Access Compliance Report Public Rights-of-Way (Curb Ramps)

Main Street: GARLAND_AVE Cross Street: RED_HILL_AVE Location: S

ADA ID: RPRK211014143243 Ramp Type: Type 4 - Parallel Initial Pass/Fail: Fail Overall Compliance: No Severity Score: 2

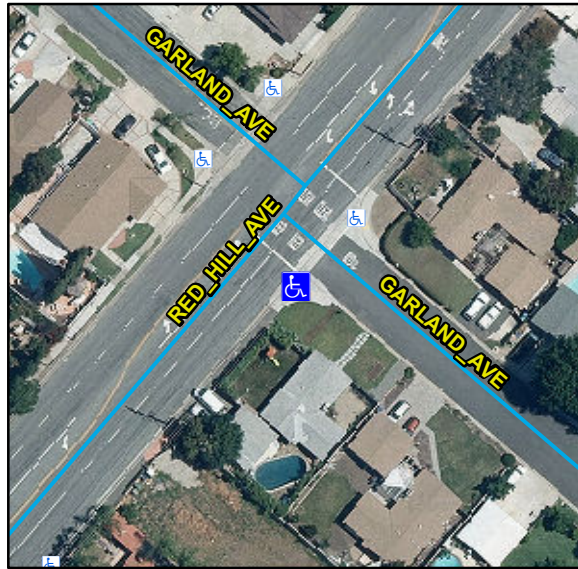
Remove & Replace Curb Ramp With Two New Directional Ramps or Equivalent.

Compliance	Description	Data	Compliance	Description	Data
N/A	Ramp Length LT (in)	84	N/A	Ramp Length RT (in)	87
Yes	Ramp Width LT (in)	53	Yes	Ramp Width RT (in)	52
Yes	Ramp Run Slope LT (%)	7.3	Yes	Ramp Run Slope RT (%)	6.9
No	Ramp Cross Slope LT (%)	2.6	No	Ramp Cross Slope RT (%)	2.1
N/A	Landing Present	N/A	N/A	DWS Provided	N/A
N/A	Landing Length (in)	N/A	N/A	DWS Contrast	N/A
N/A	Landing Width (in)	N/A	N/A	DWS Length (in)	N/A
N/A	Landing Run Slope (%)	N/A	N/A	DWS Full Width	N/A
N/A	Landing Cross Slope (%)	N/A		DWS Offset Type	N/A
N/A	Landing Movement Obstructed?	N/A	N/A	DWS Offset Left (in)	N/A
	Landing Movement Type	N/A	N/A	DWS Offset Right (in)	N/A
N/A	Landing Shared	N/A			
N/A	Clear Space	Yes			
N/A	Clear Space To Crosswalk (in)	N/A			
N/A	Marked Crosswalk 1	No	N/A	Marked Crosswalk 2	No
	Crossing 1 Direction	NE		Crossing 2 Direction	NW
	Marked Crosswalk 1 Width (in)	N/A		Marked Crosswalk 2 Width (in)	N/A

R304.5.3, STD 1115
